# UNITED STATES PATENT AND TRADEMARK OFFICE

APPLICATION NO.	FILING DATE	FIRST NAMED INVENTOR	ATTORNEY DOCKET NO.	CONFIRMATION NO.
10/614,136	07/08/2003	Chin-Liang Lin	L9079.03103	5979

## Office Action Summary

## DETAILED ACTION

Fig. 1

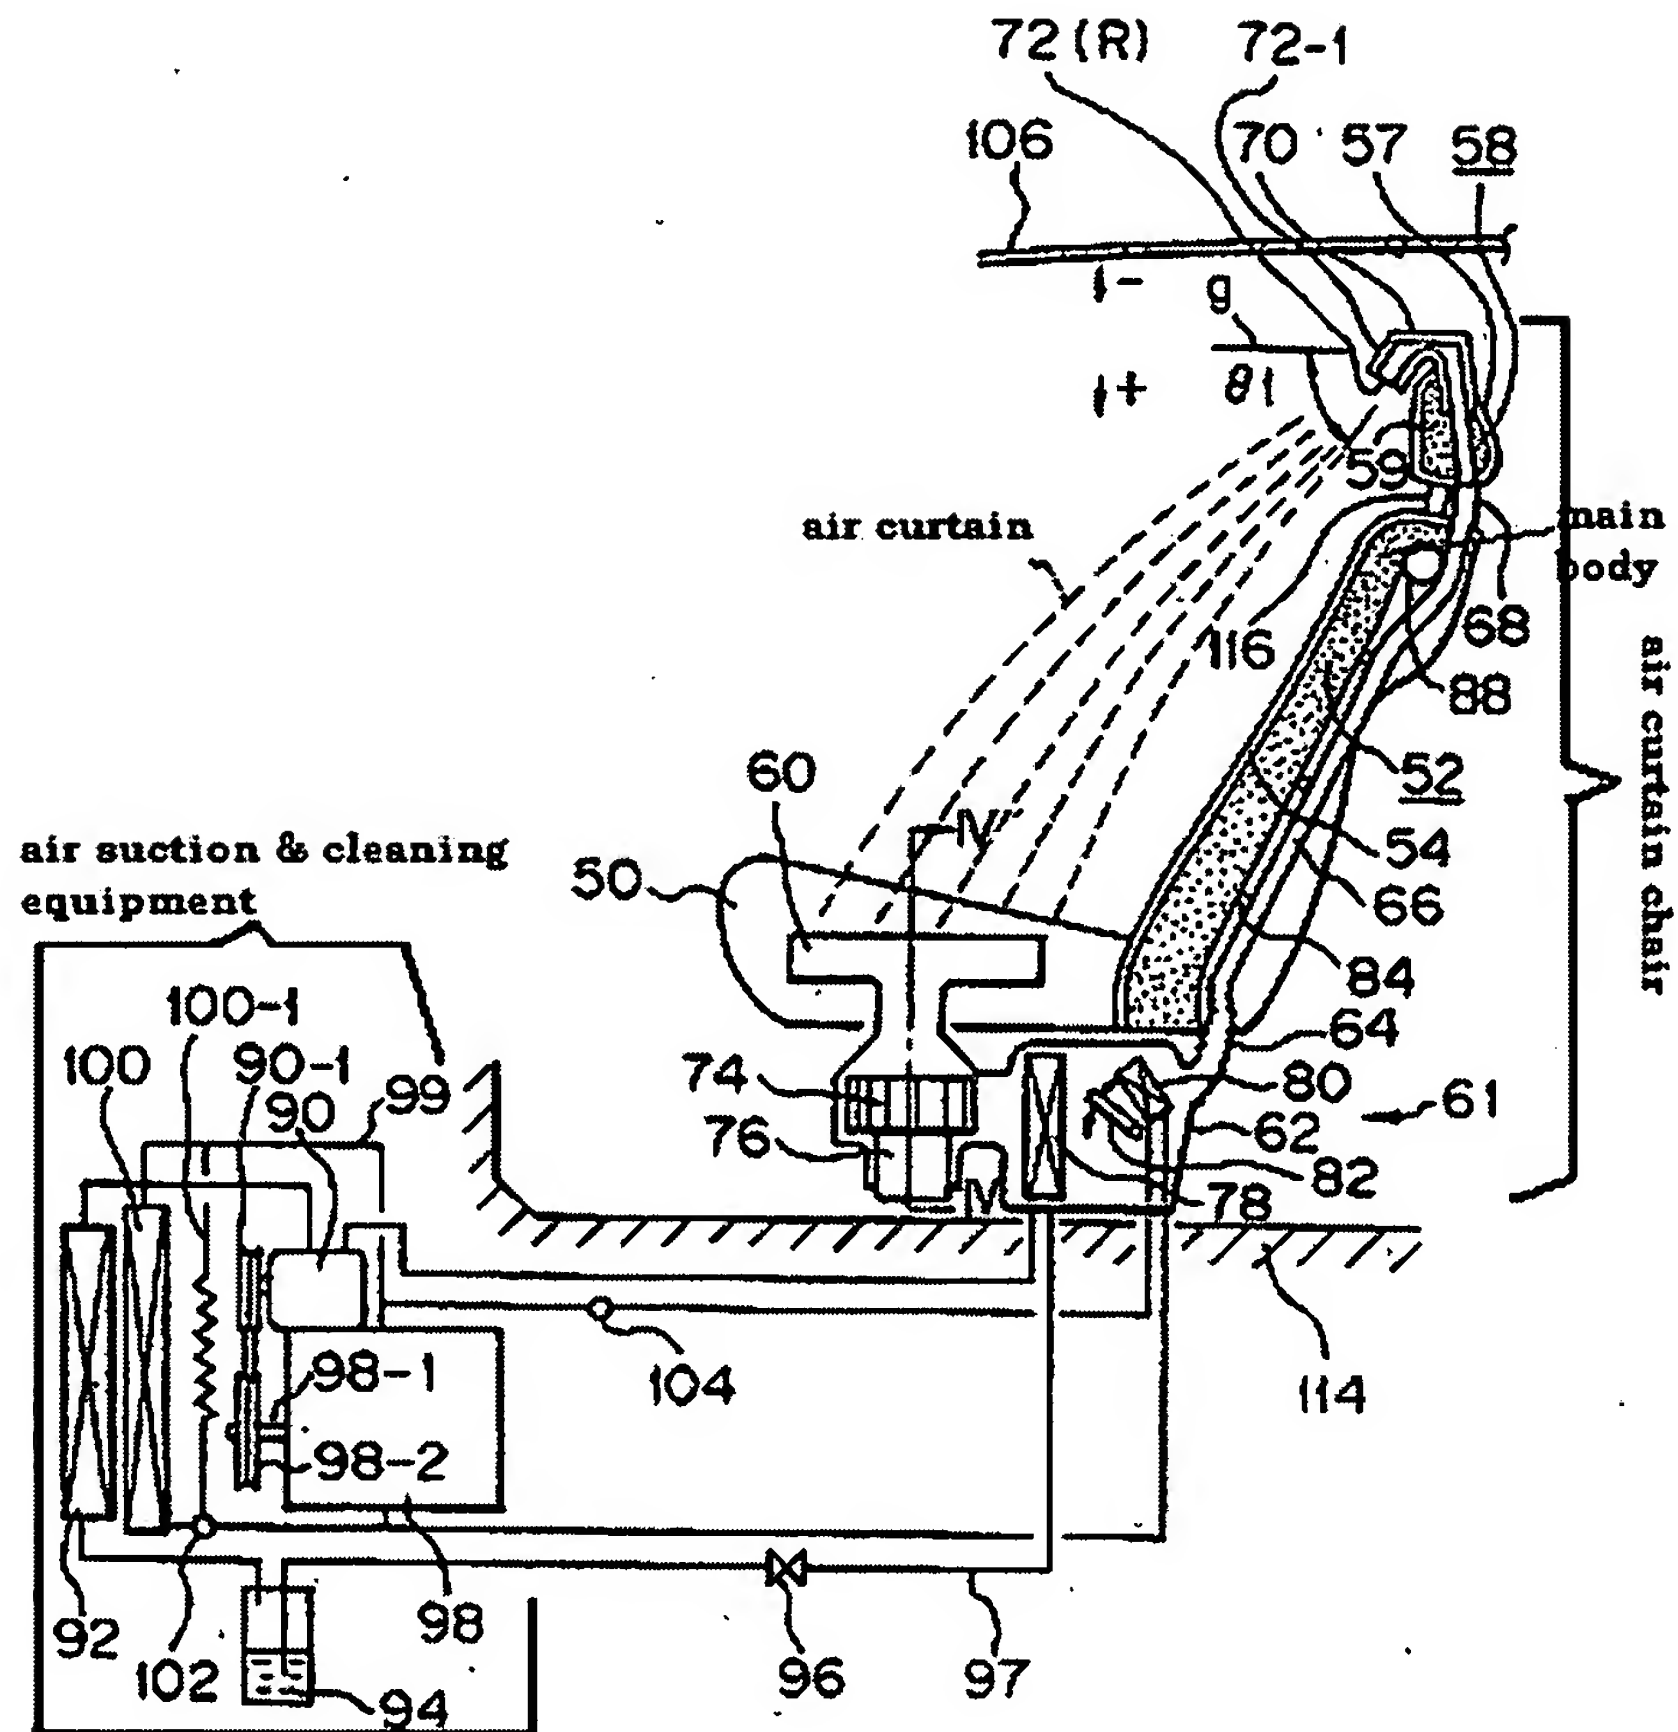
3. **As to claim 1**, Inoue et al. disclose a chair (car seat) with air-curtain shield (see Fig.1 and col.16 lines 65-68) comprising an air-curtain chair (see attached Fig.1) with a main-body (see attached labeled Fig.1) and at least one set of air-suction and cleaning equipment (see Fig.1 reference objects 90 and 92) which are connected to form an air filtration and circulation system to generate air-curtain shield and filtrate the air making it suitable for cyclic-use, and the said air-suction and cleaning equipment (see Fig.1 reference objects 90 and 92) has an air suction inlet (see attached Fig.41) and an air discharging outlet (see attached Fig.41) through which when the air-suction and cleaning equipment (see Fig.1 reference objects 90 and 92) is in operation, the air is sucked into the equipment for filtration and cleaning treatment, and then discharged from the air discharging outlet (see attached Fig.41); wherein the said main-body (see attached Fig.1) of the air-curtain chair comprises a seat surface (Fig.1 reference object 50), a seat back (Fig.1 reference object 52) and two hood-walls (see attached Fig.33); the said seat back extends from the bottom at the rear edge of the seat surface upwardly and then horizontally to form a top-hood (see attached Fig.33) which, together with the hood-wall positioned on both sides of the seat back, forms a bag-shaped inner space (see attached Fig.33) inside the main-body of the said air-curtain chair, at the two corners along the front edge of the seat surface are the suction slots (see Fig.4B reference object 60) arranged in a manner symmetric to each other with an air suction tube connector installed at its bottom, and the air suction tube connector (see attached Fig.41) is connected to the air suction inlet (see Fig.41) of the said air-suction and cleaning equipment by means of an air suction tube (see Fig.41 reference object 201); inside the seat back and the top-hood is an air flow passage (Fig.1 reference object 66) extended from the bottom of the seat back to the front edge of the top-hood with an air supply tube connector (see attached Fig.41, Fig.1 reference object 64) installed at the end of the bottom portion of the seat back which is connected to the air discharging outlet (see attached Fig.41) of the said air-suction and cleaning equipment

by means of an air supply tube (see Fig.41 reference object 203), and at the bottom of the top-hood (see attached Fig.33) near the front edge is an air outlet (see Fig.1 reference object 72) which can generate an air-curtain shaped flow stream with a range covering at least the whole front edge of the said seat surface (see attached Fig.1).

4. **As to claim 2**, Inoue et al. disclose an air outlet (see attached Fig.41) is located at the bottom of the said top-hood at the location corresponding to the air suction slot on the said seat surface (see Fig.1 reference objects 60, 72, col.16 lines 60-68, and col.17 lines 2-5).

5. **As to claim 4**, Inoue et al. disclose the air suction slot positioned at the corner of the said seat surface (see attached Fig. 1 reference object 60) has outer width of slot opening greater than the inner width of the opening to form a hood-shaped nozzle (see attached Fig.4B, col.11 lines 33-38).

**Fig. 4(B)**

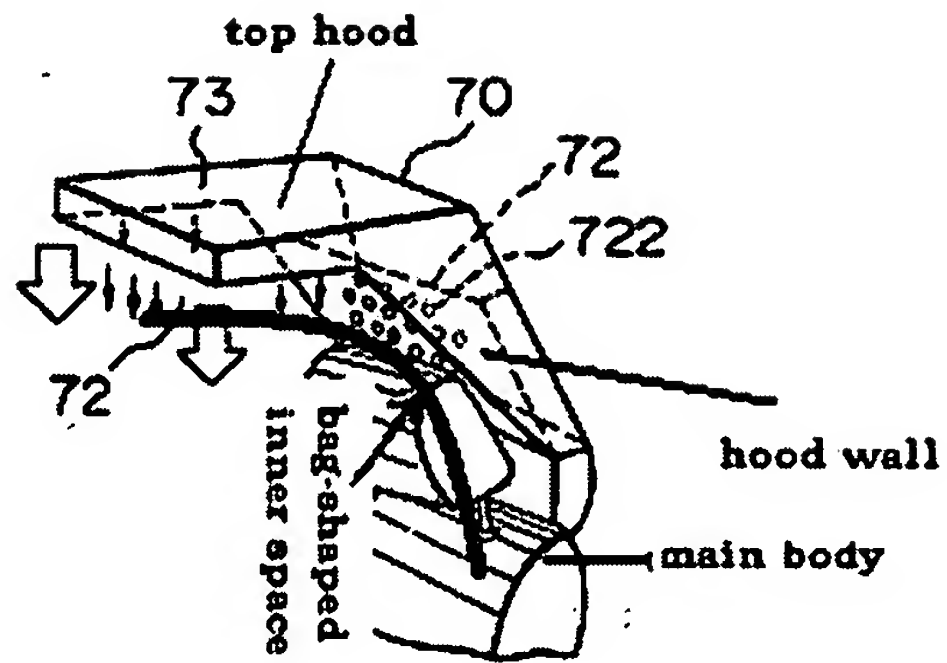
6. **As to claim 7**, Inoue et al. disclose the air suction slots at the corners of the said seat surface are in rectangular shape (see Fig.4B reference object 60 and col.7 lines 42-44).

**Fig. 41**

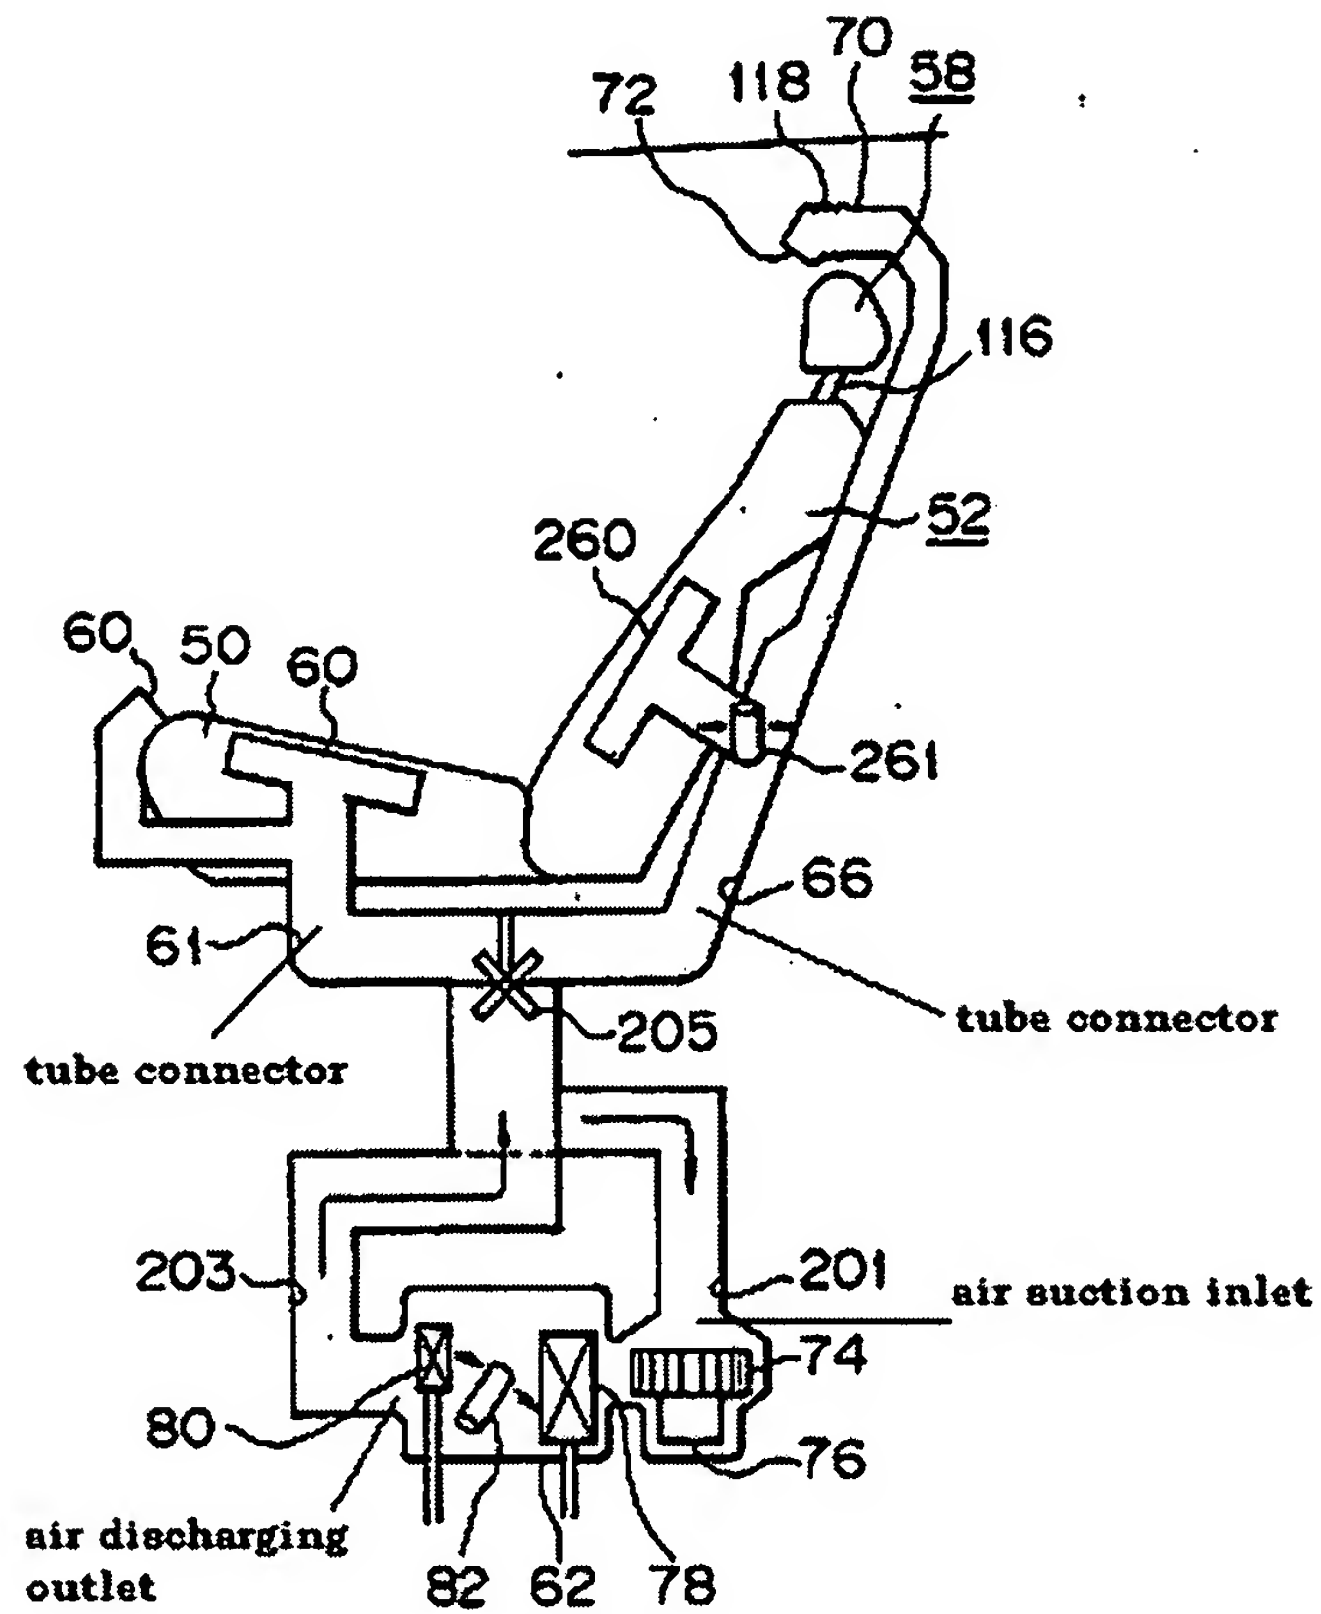
10. **As to claim 9**, applicant considers medical level air-suction and cleaning equipment comprising an air suction inlet (see attached Fig.41), an air discharging outlet (see attached Fig.41) and an air filtration-sterilization unit (compressor and condenser) (see attached Fig.1 reference objects 90 and 92). Therefore, it would have been obvious to one of ordinary skill in the art to consider the air suction and cleaning equipment as disclosed by Inoue et al. to be equipment of medical level.
